McClellan Lake Operation

Licence Amendment – JEB TMF Expansion

Commission Hearing
October 4, 2021
CMD 21-H6.A

Components of JEB TMF and stratigraphy of the site (image not to scale)
(Source: Orano)

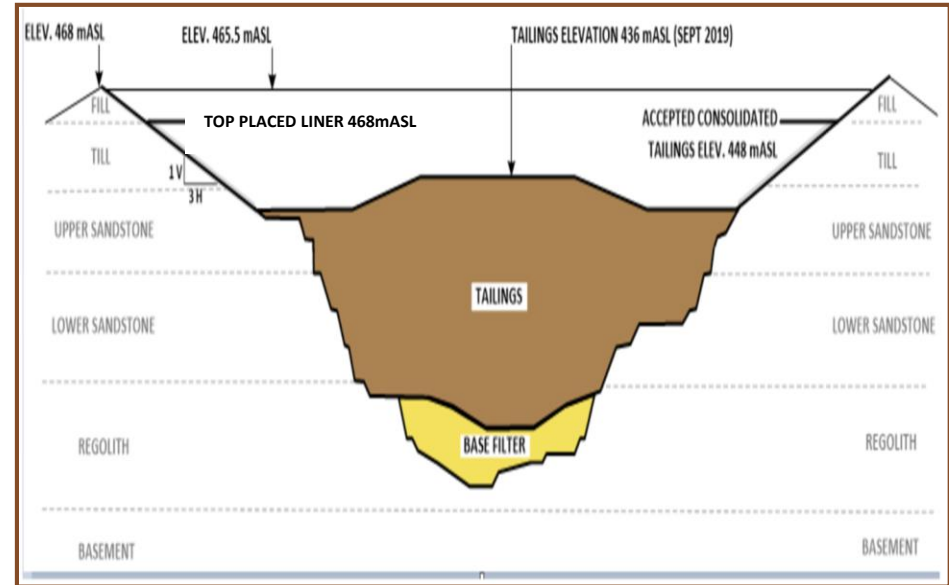
- Site investigation
 - Organics or organic soils: 0 - 4 m
 - Till: 10 - 28 m
 - Sandstone: ~ 60 - 200 m
 - Regolith: ~ 50 m
 - Crystalline basement rock
- Material characterization

Site investigation and material characterization has verified appropriate site soil conditions for the JEB TMF expansion

Two cross-sections showing designed embankment slope configuration (Source: Orano)

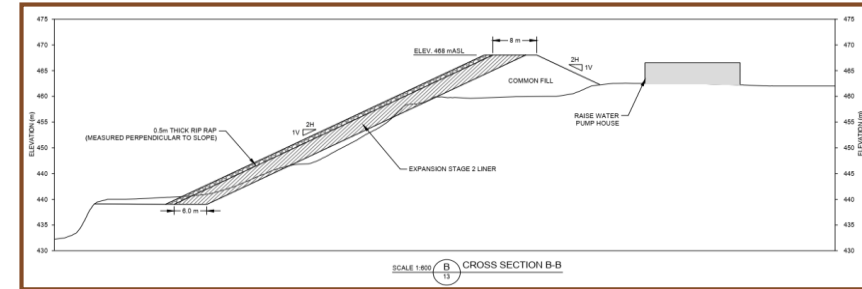
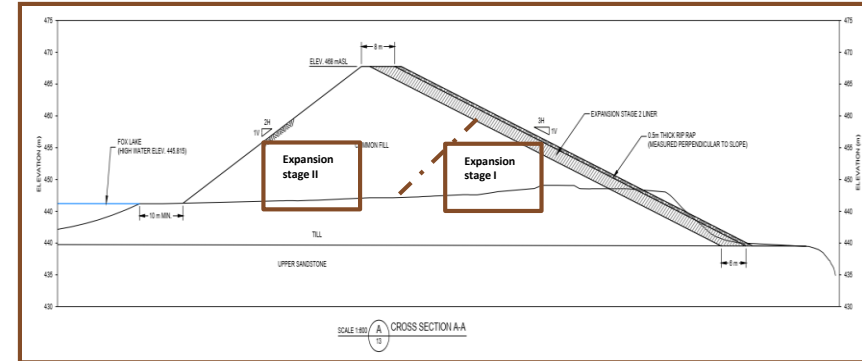
CNSC staff evaluation of embankment design

- Supported with slope stability analysis
- Sufficient capacity for extreme weather
- Slopes will be flattened during decommissioning
- Lessons learned from Mount Polley tailings dam breach taken into account

JEB TMF expansion embankment is designed to ensure both short-term and long-term stability and safety

Illustration of proposed landform for decommissioned JEB TMF (Source: Orano)

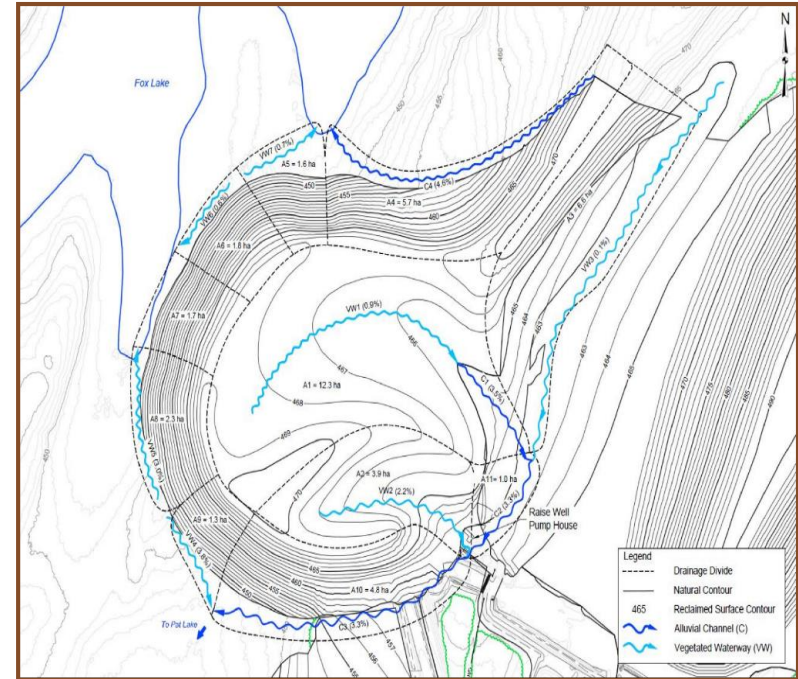
- Used a geomorphic approach and a structural approach
- Current design is preliminary
- Final detailed design will be provided prior to the JEB TMF decommissioning

The final landform will ensure the long-term performance of the decommissioned JEB TMF
